Re: Florida Power & Light Company
Proposed Turkey Point Units 6 and 7
Docket Nos. 52-040 and 52-041
Response to NRC Request for Additional Information Letter No. 037
(eRAI 5896) SRP Section - 02.05.02 Vibratory Ground Motion

NRC RAI Letter No. PTN-RAI-LTR-037

SRP Section: 02.05.02 - Vibratory Ground Motion

NRC RAI Number: 02.05.02-2 (eRAI 5896)

Figure 3c: EPR1 (FSAR Reference 242) Mid Continent 10Hz weighted mean attenuation curve for a magnitude 8 earthquake.

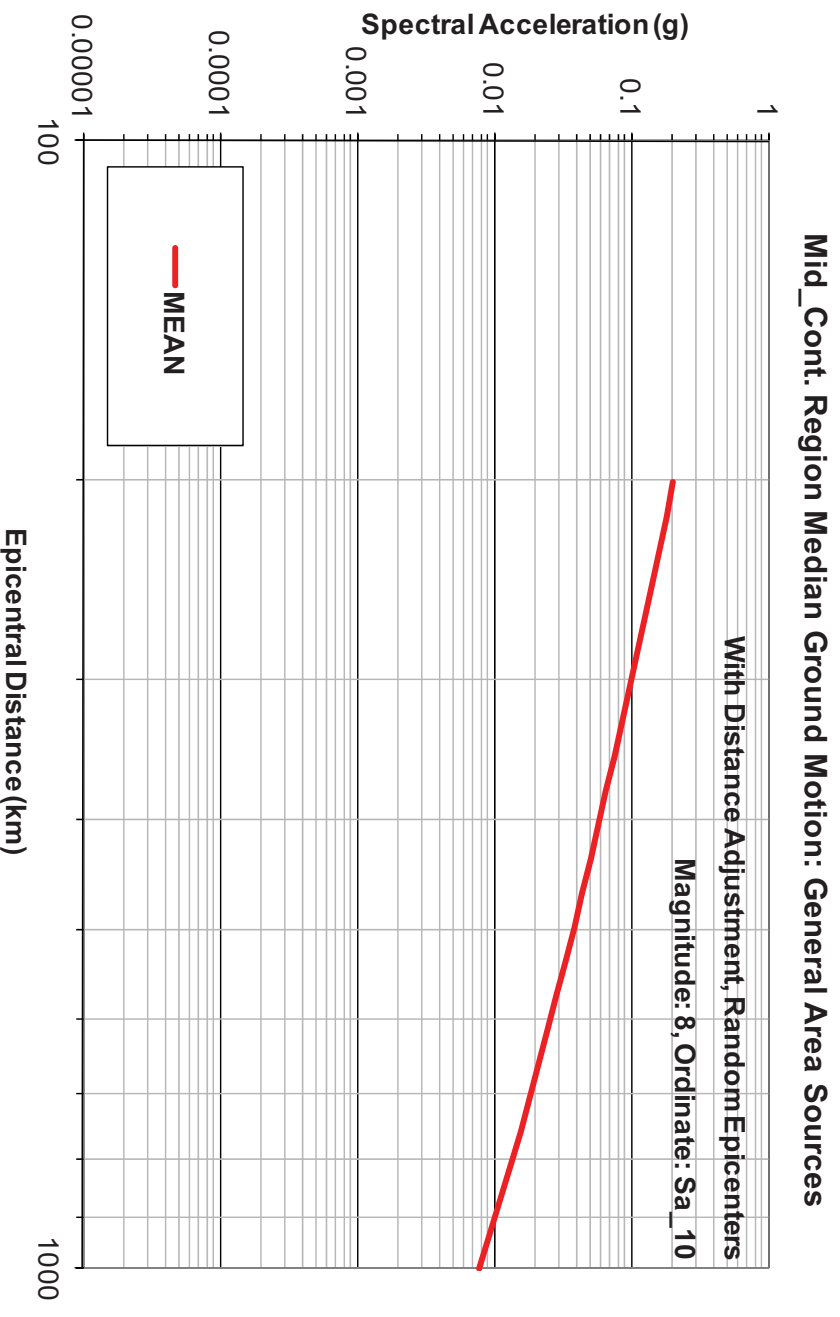
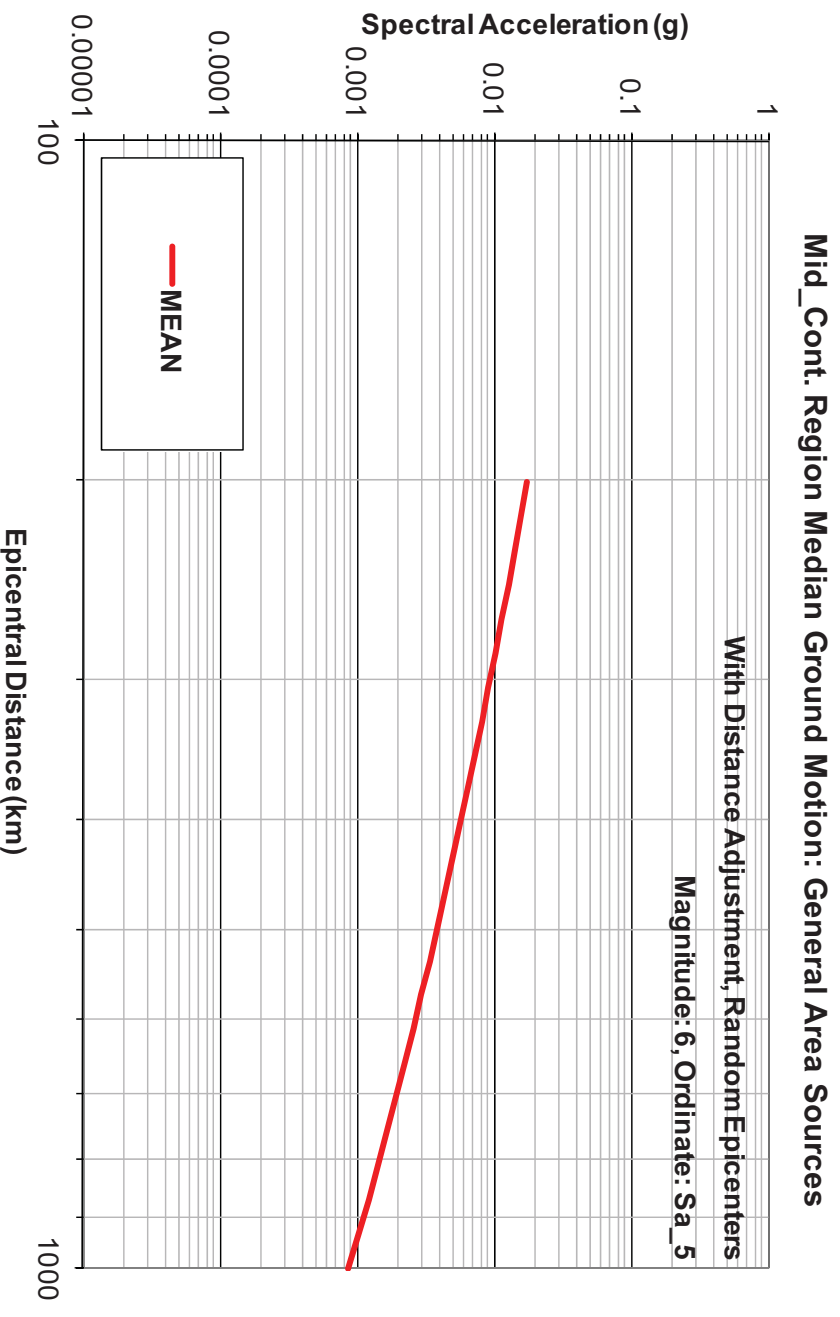
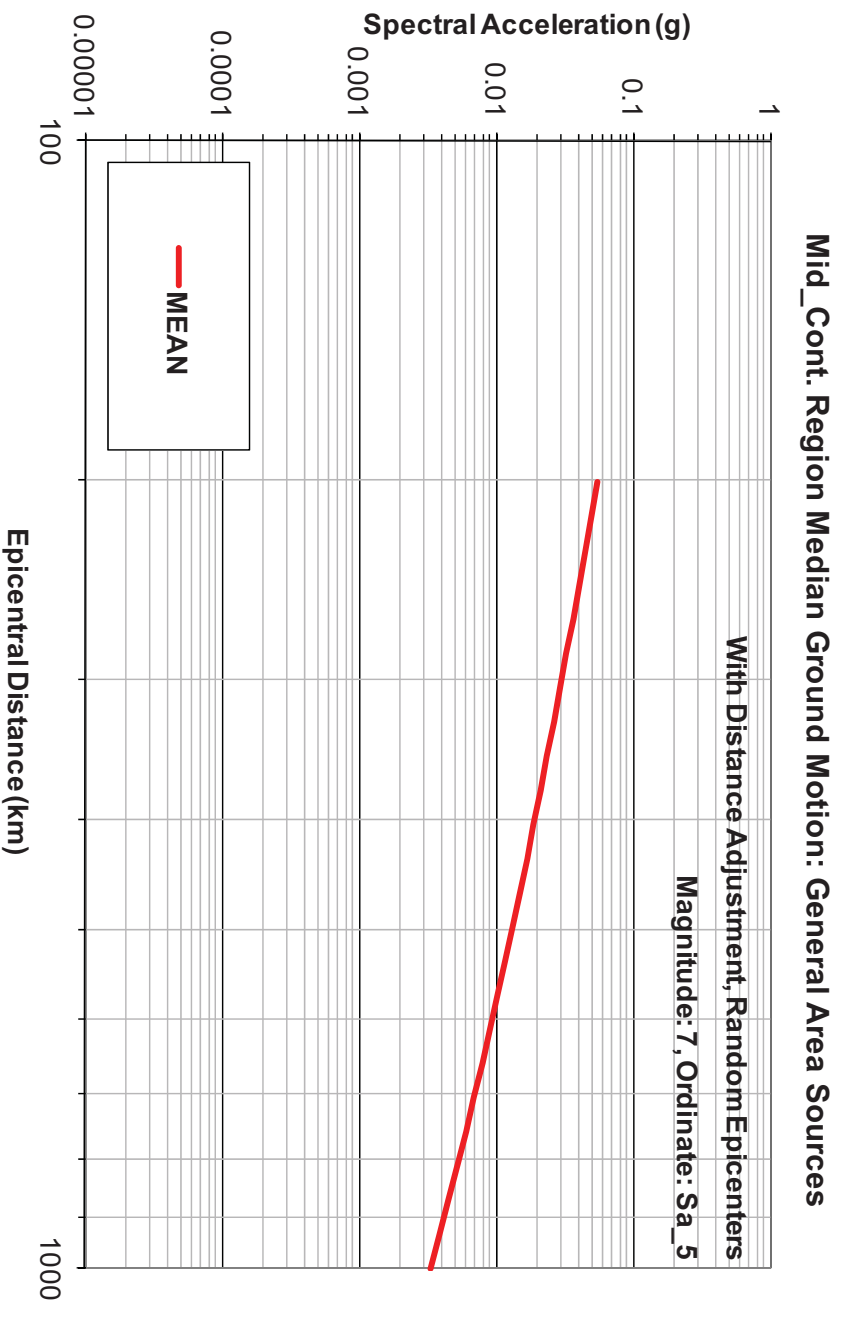
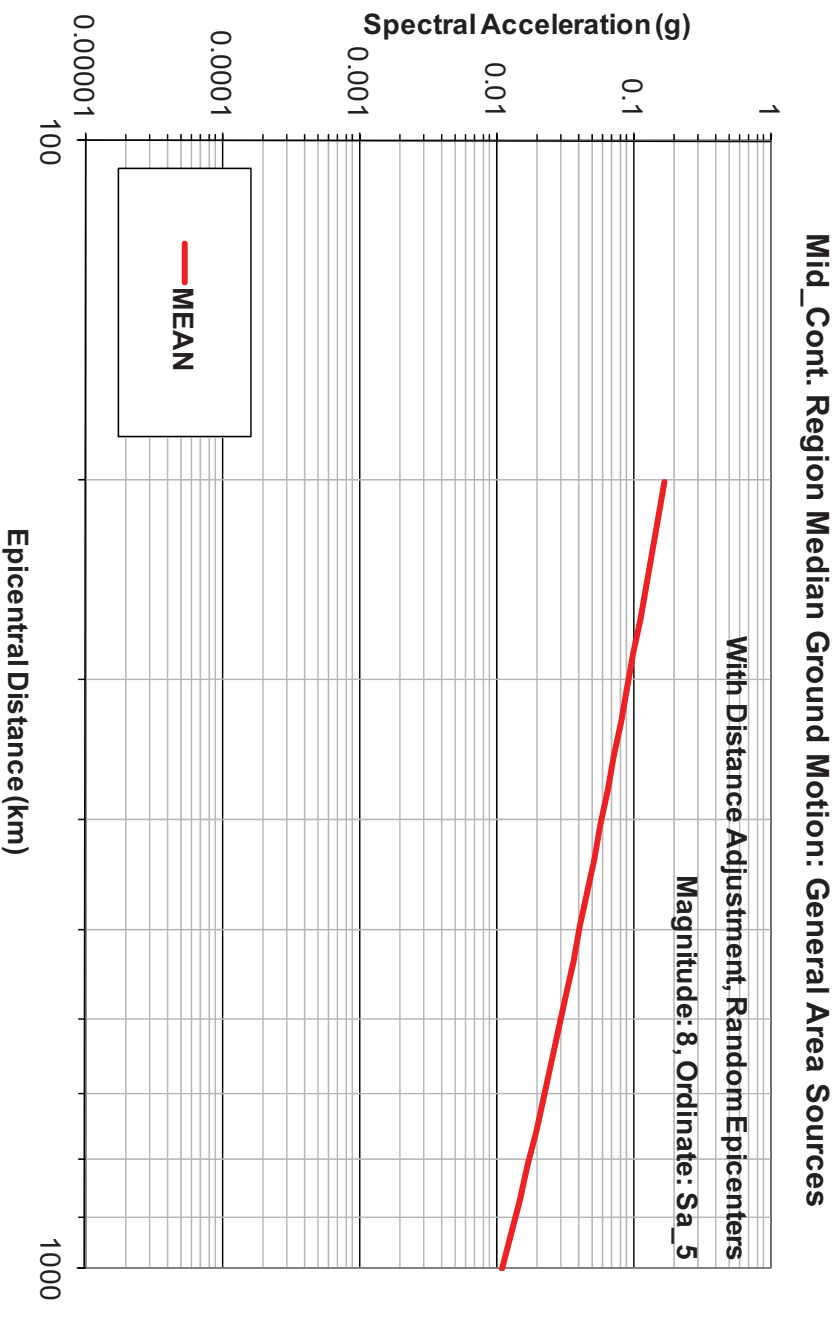
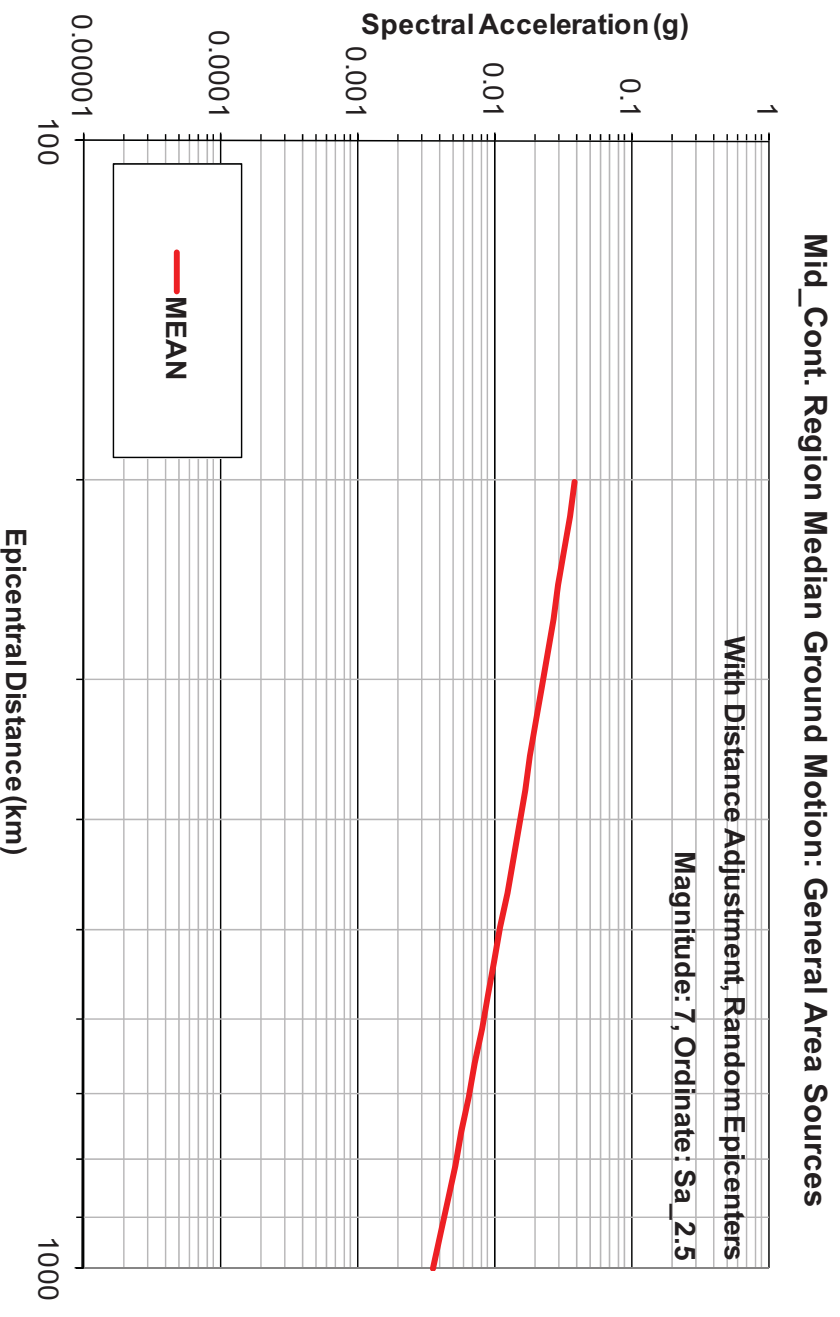
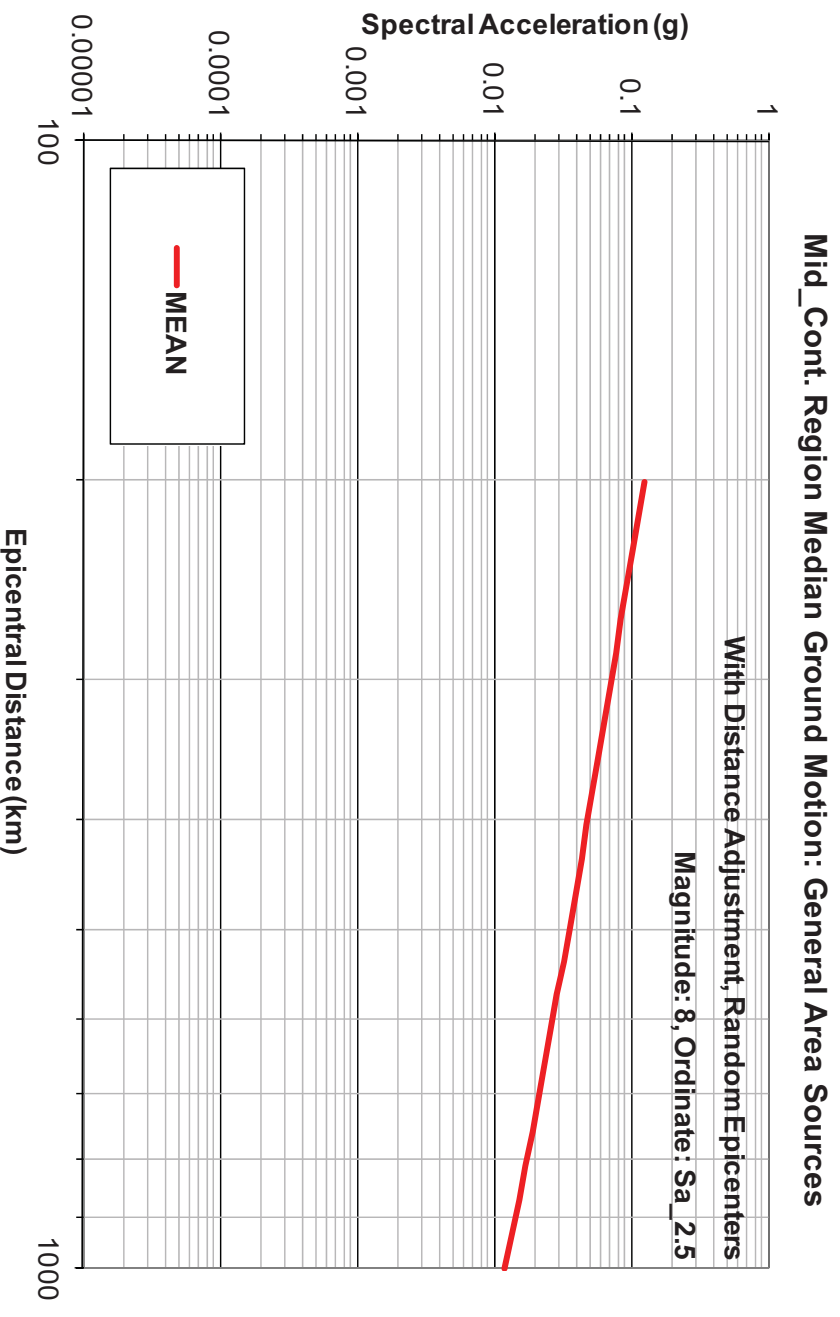
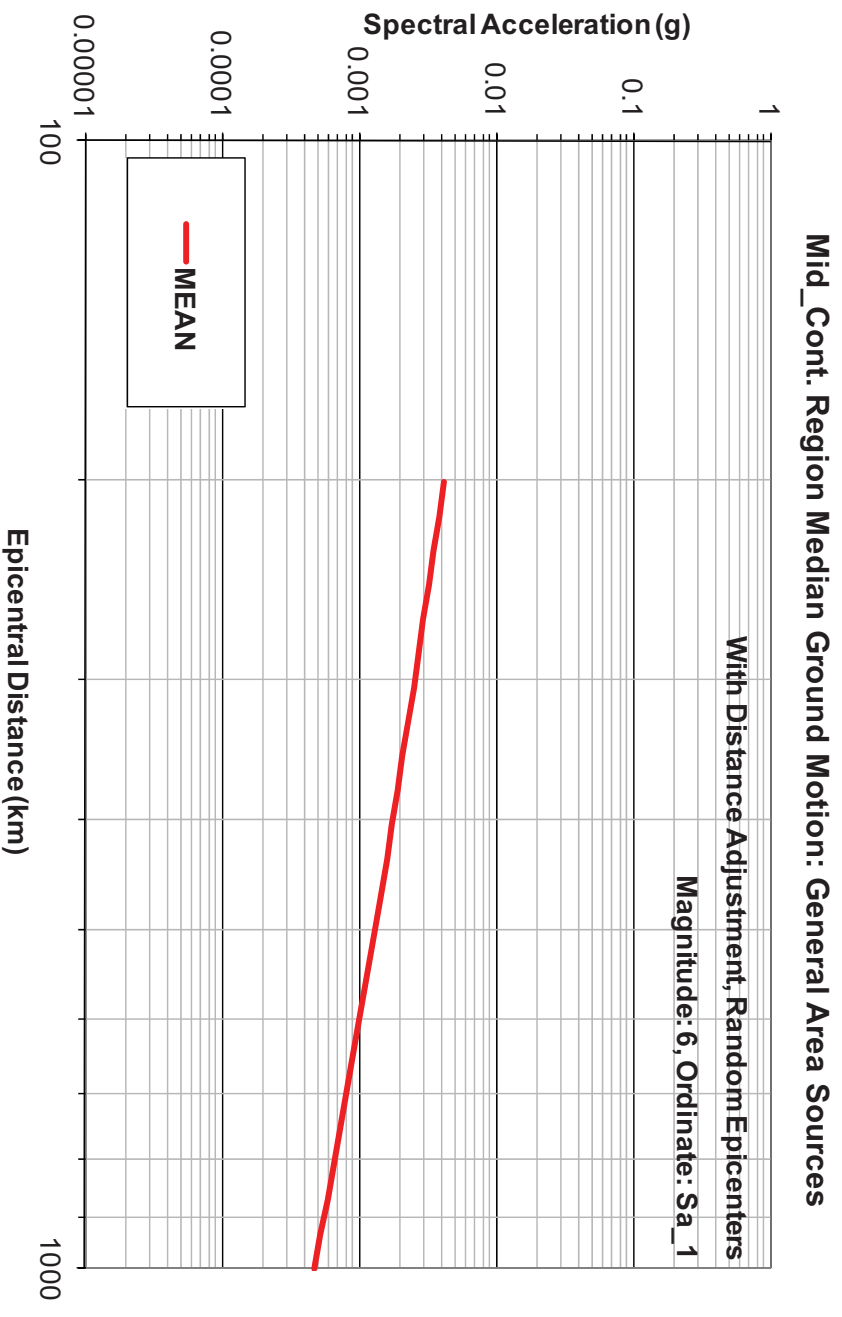
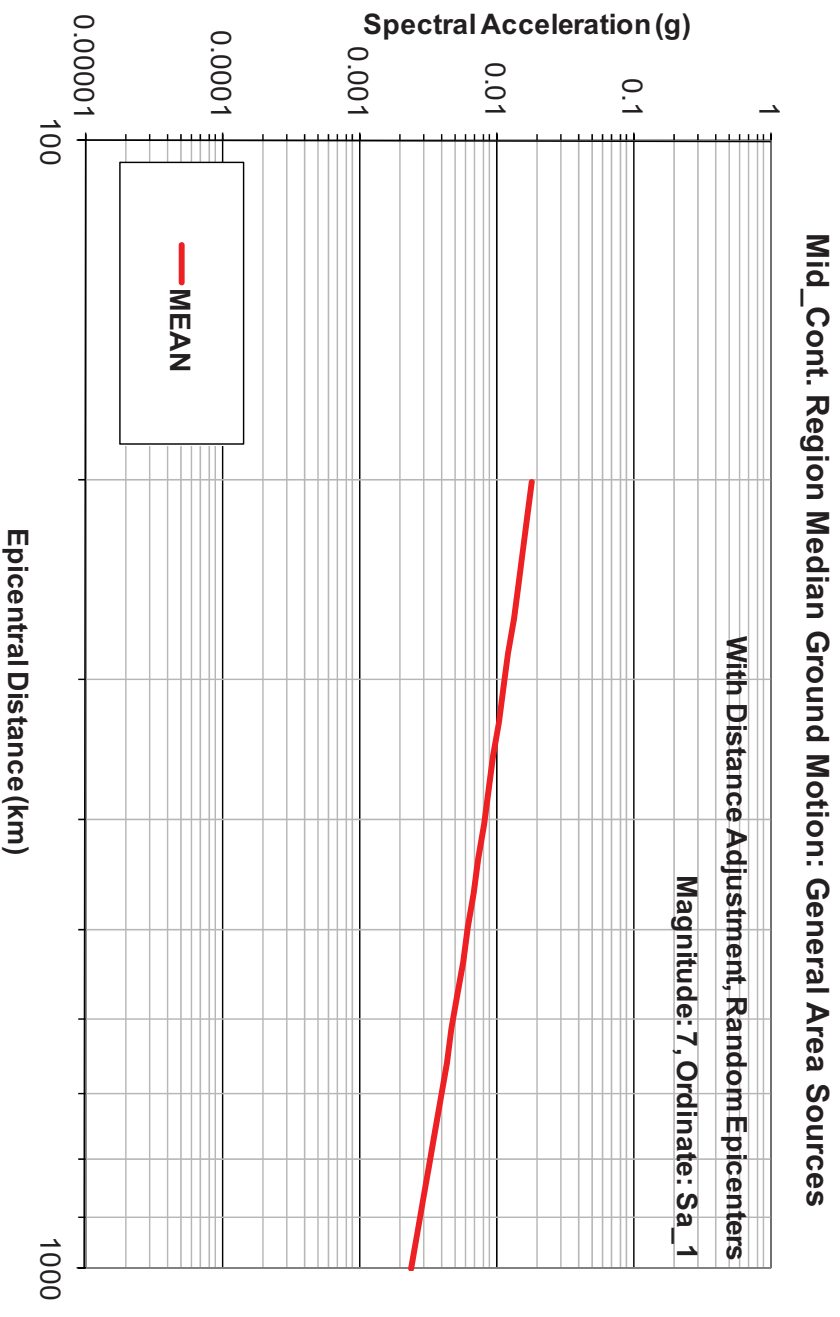
- d. In order for the staff to be able to compare the new Caribbean GMPEs with the 2004/2006 EPRI mid-continent GMPEs, please provide plots showing both ground motion models for earthquake magnitudes of 6.0, 7.0, and 8.0 in the distance range of 200 km to 1000 km at all seven frequencies defined in the EPRI 2004 and 2006 GMPEs.

Ground motion attenuation curve plots are provided for the EPRI (FSAR References 242 and 203) and Caribbean ground motion prediction equations (GMPEs). Note that EPRI (FSAR Reference 203) is only a recommendation for the associated aleatory uncertainty and therefore does not impact the comparison plots of the weighted mean ground motion

attenuation curve. The plotted mean attenuation curve is the weighted mean of the individual median attenuation curves as defined in EPRI (FSAR Reference 242). These attenuation plots are provided for three specific moment magnitude (M_w) values: 6, 7, and 8 for distances between 200 km and 1,000 km. Note that the EPRI (FSAR Reference 242) ground motion attenuation model is defined as a function of epicentral distance, whereas the Caribbean ground motion attenuation model is defined as a function of hypocentral distance. However, because the closest distance is 200 km, the difference between the epicentral and hypocentral distances would be less than 1% for a typical crustal depth of 10 km and even smaller for larger distances out to 1,000 km.

The weighted mean ground motion attenuation curves for the EPRI (FSAR Reference 242) model are given in Figures 1 through 7 for the three magnitudes and seven spectral frequencies requested in the RAI. The weighted mean Caribbean ground motion attenuation curve plots for the same suite of magnitudes, distances, and spectral frequencies are shown in Figures 8 through 14.
